Contract No. YL/2023/03
Hung Shui Kiu/Ha Tsuen New Development Area Second Phase Development – Contract 3 – Site Formation and Engineering Infrastructure Works

Environmental Permit No. EP-530/2017
Submission of Supplementary Contamination Assessment Plan (Batch 4)

Supplementary Contamination Assessment Plan (Batch 4)

Appendix: B	RAMBOLL
Title: Photo Records of Site Surveys	Drawn by: SC Checked by: ZC
Project: Contract No. YL/2023/03 Hung Shui Kiu / Ha Tsuen New Development Area Second Phase Development - Contract 3 - Site Formation and Engineering Infrastructure Works	Rev.: 1.1 Date: Nov 2025

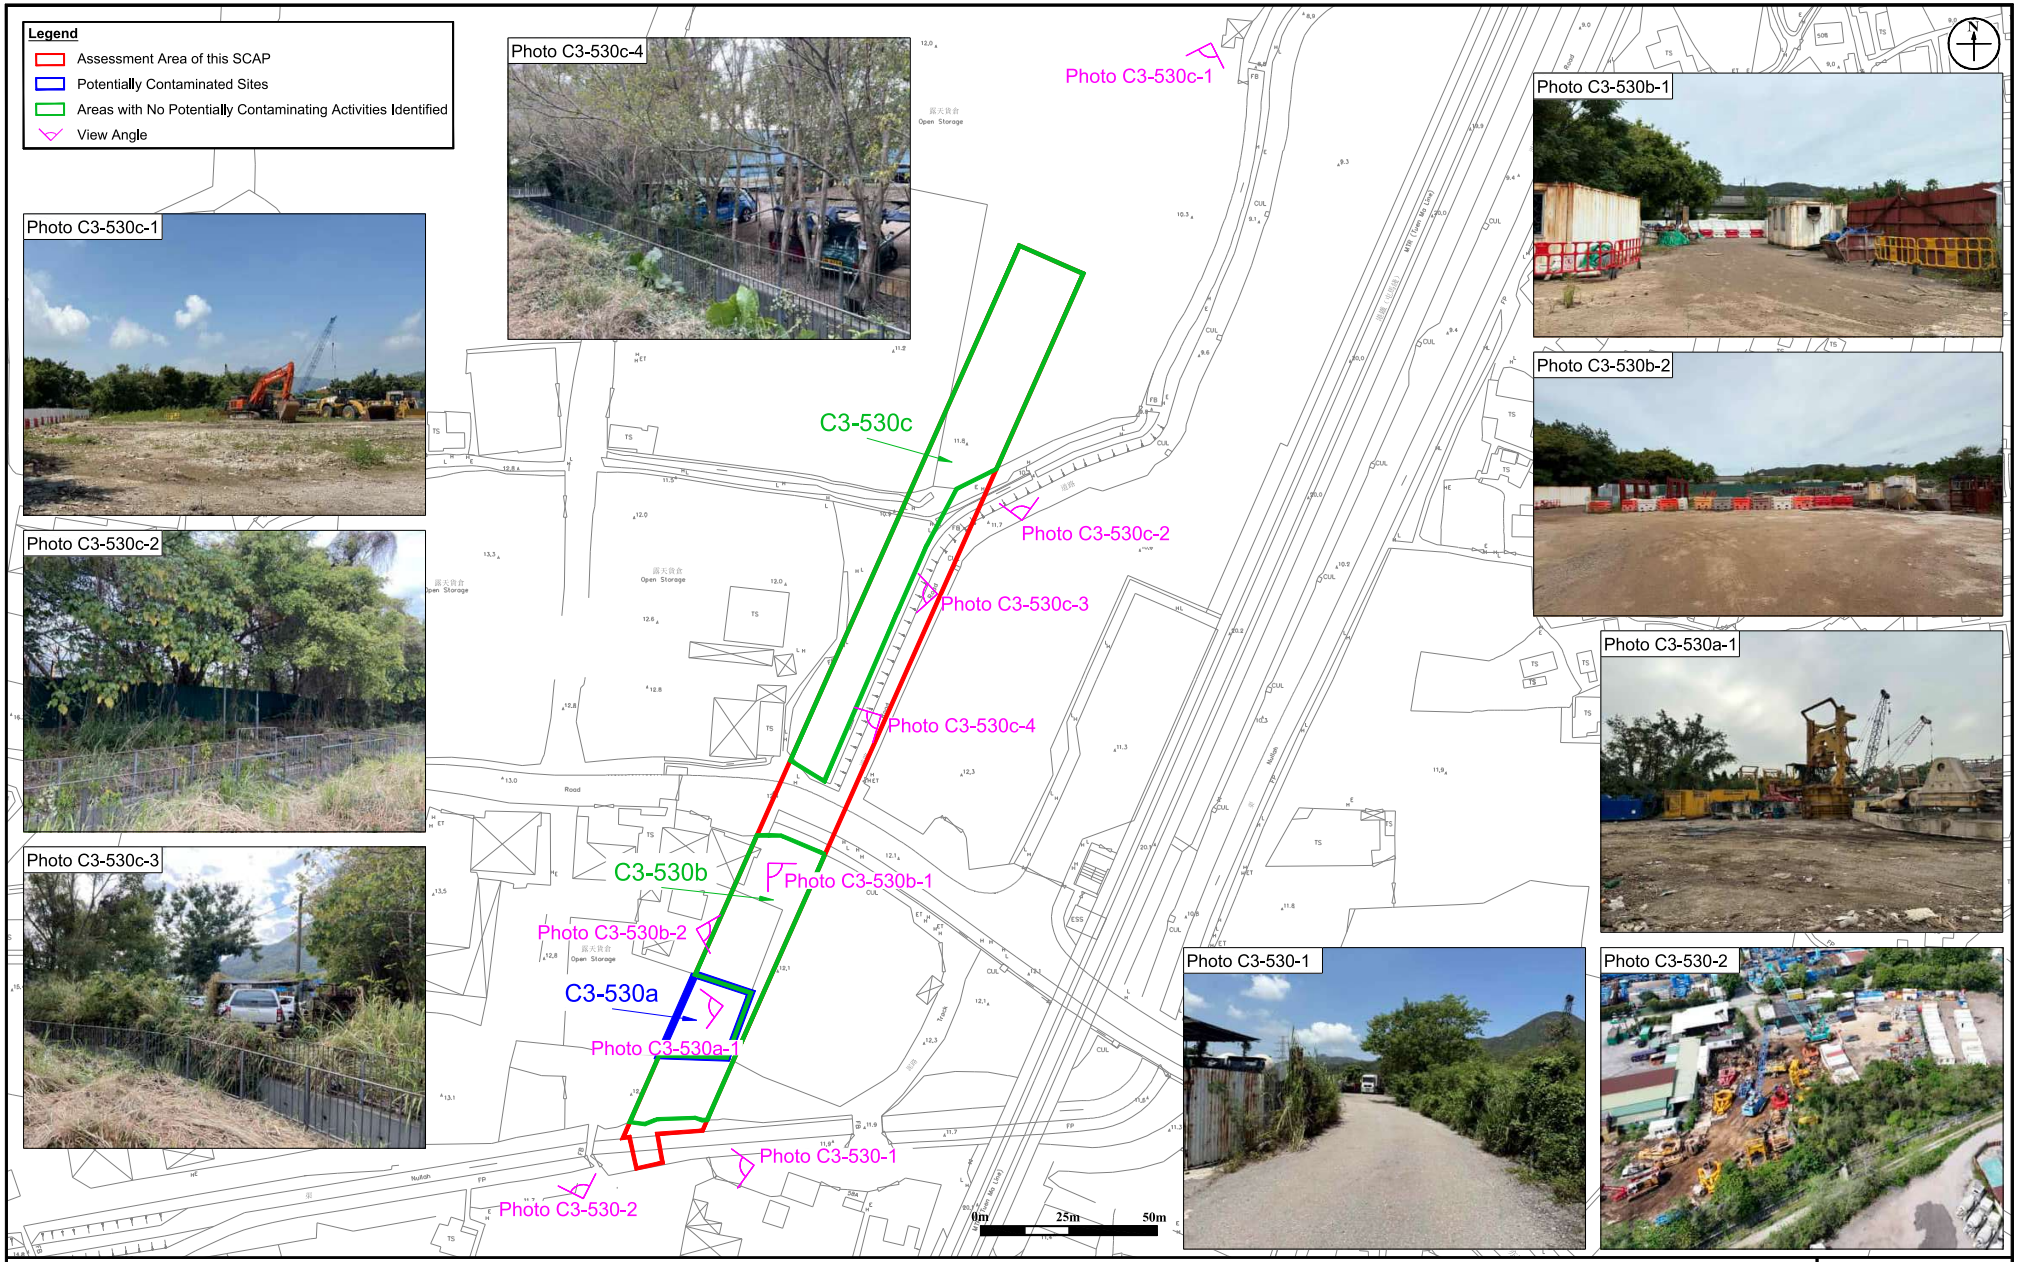
1. Please highlight all the changes/amendments in the next submission.	Noted.
2. C3-530c, C3-530b, Part E1a & E2: No comment.	Noted.
3. Appendix B: Please label each photo with the corresponding site name.	Noted and Appendix B has been updated.
